**LIGHTING CONSTRUCTION**

REVISION	BY	DATE
CONDUIT AND LIGHTING REMOVED FROM CONTRACT	TFD	11/05/13

PROJECT NAME: RUTLAND CITY	PLOT DATE: 11/5/2013
PROJECT NUMBER: STP 019-3(57)	DRAWN BY: PZA
FILE NAME: ...rur.lght.dgn	CHECKED BY: GAE
PROJECT LEADER: GAE	SHEET 359A OF 392
DESIGNED BY: TFD	
<b>LIGHTING &amp; ELECTRICAL PLAN LE-04</b>

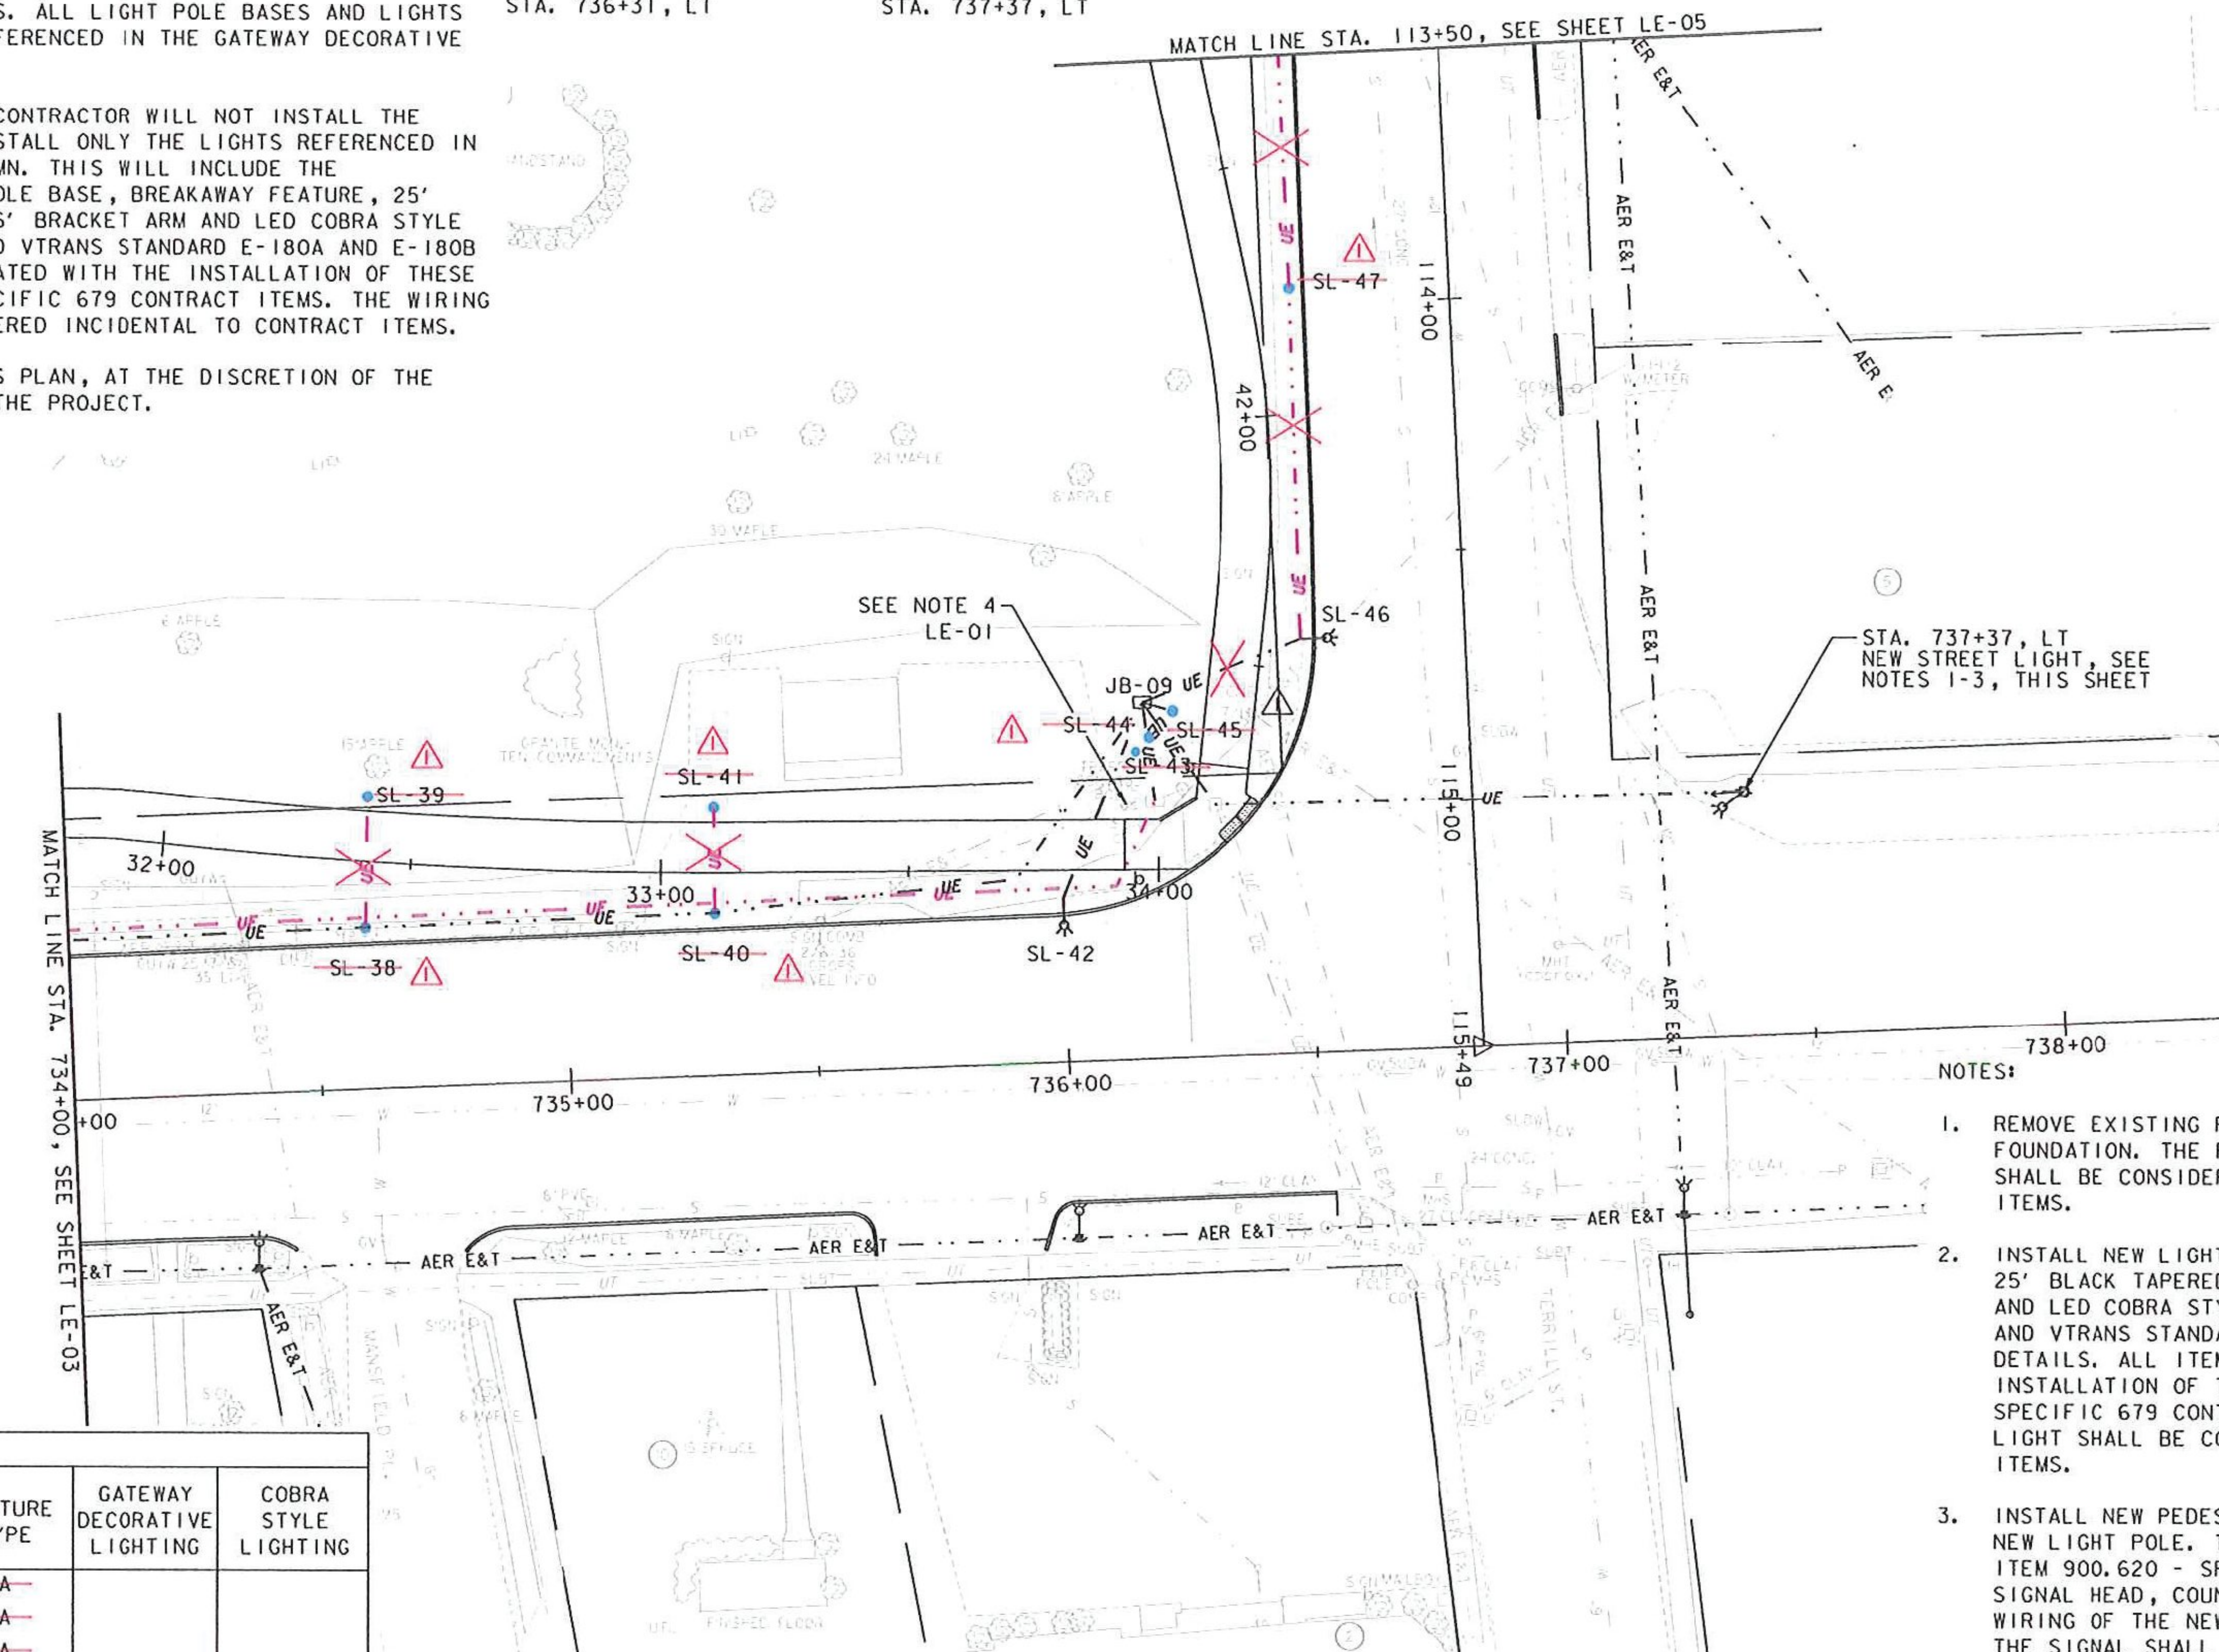
SPECIFIC FEATURES OF THE LIGHTING DESIGN WILL BE CONSTRUCTED AT THE DISCRETION OF THE CITY. THE CONTRACTOR SHALL INSTALL THE DECORATIVE LIGHTS ACCORDING TO THE DETAILS PROVIDED IN THIS PLAN SET AND THE SPECIAL PROVISIONS. ALL LIGHT POLE BASES AND LIGHTS WILL BE INSTALLED THAT ARE REFERENCED IN THE GATEWAY DECORATIVE LIGHTING COLUMN.

IF REQUIRED BY THE CITY, THE CONTRACTOR WILL NOT INSTALL THE DECORATIVE LIGHTS BUT WILL INSTALL ONLY THE LIGHTS REFERENCED IN THE COBRA STYLE LIGHTING COLUMN. THIS WILL INCLUDE THE INSTALLATION OF A NEW LIGHT POLE BASE, BREAKAWAY FEATURE, 25' BLACK TAPERED ALUMINUM POLE, 6' BRACKET ARM AND LED COBRA STYLE LUMINAIRE. REFER TO LGT-03 AND VTRANS STANDARD E-180A AND E-180B FOR DETAILS. ALL ITEMS ASSOCIATED WITH THE INSTALLATION OF THESE LIGHTS WILL BE PAID UNDER SPECIFIC 679 CONTRACT ITEMS. THE WIRING OF THE LIGHTS SHALL BE CONSIDERED INCIDENTAL TO CONTRACT ITEMS.

ALL OTHER LIGHTS SHOWN ON THIS PLAN, AT THE DISCRETION OF THE CITY, MAY BE ELIMINATED FROM THE PROJECT.

- NOTES:**
1. REMOVE EXISTING PEDESTRIAN SIGNAL HEAD, POLE AND FOUNDATION. THE REMOVAL OF THE EXISTING SIGNAL SHALL BE CONSIDERED INCIDENTAL TO 679 CONTRACT ITEMS.
  2. INSTALL NEW LIGHT POLE BASE, BREAKAWAY FEATURE, 25' BLACK TAPERED ALUMINUM POLE, 6' BRACKET ARM AND LED COBRA STYLE LUMINAIRE. REFER TO LGT-03 AND VTRANS STANDARD E-180A AND E-180B FOR DETAILS. ALL ITEMS ASSOCIATED WITH THE INSTALLATION OF THE NEW LIGHT WILL BE PAID UNDER SPECIFIC 679 CONTRACT ITEMS. THE WIRING OF THE LIGHT SHALL BE CONSIDERED INCIDENTAL TO CONTRACT ITEMS.
  3. INSTALL NEW PEDESTRIAN SIGNAL HEAD, COUNTDOWN, ON NEW LIGHT POLE. THE COUNTDOWN SHALL BE PAID AS ITEM 900.620 - SPECIAL PROVISION (PEDESTRIAN SIGNAL HEAD, COUNTDOWN) (US ROUTE 7 @ US BR 4). WIRING OF THE NEW PEDESTRIAN SIGNAL AND TIMING THE SIGNAL SHALL BE CONSIDERED INCIDENTAL TO THE ITEM.
  4. FOR LIGHTING AND ELECTRICAL NOTES SEE SHEET LE-01.
